Technical Bulletin

C-Weigh Fork Indicator Positive Battery Terminal Modification

Part No. 6932039

FK0761.eps

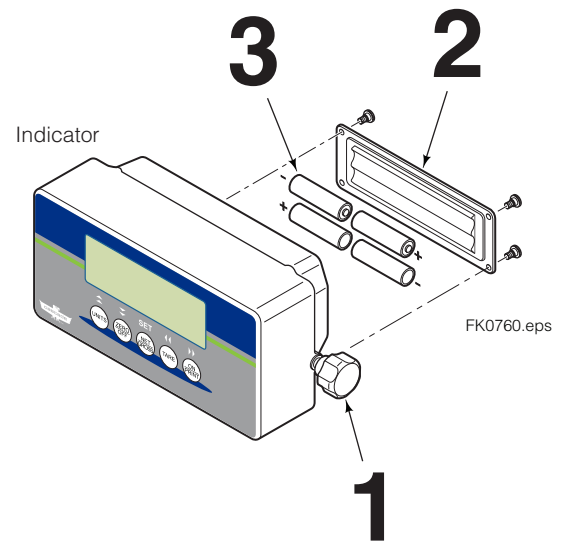
Cascade has identified an issue with battery powered C-Weigh Fork Indicators that are losing power due to a weak connection between the indicator positive contact plate and battery positive terminal. This bulletin covers indicators shipped prior to September 2018. Follow the steps below to solve the problem.

- 1 Remove the indicator from the mounting bracket.
- 2 Remove the rear battery cover from the indicator.
- 3 Remove the batteries from the indicator.
- 4 Insert a small screwdriver blade between the positive contact plate and slot in the indicator body. Turn the screwdriver blade to make a small bend the contact plate.

- 4 Make a small bend in the contact plate

- 5 Reassemble the indicator. Press the indicator power ON button to confirm battery power is restored.
- 6 Reattach the indicator to the mounting bracket.
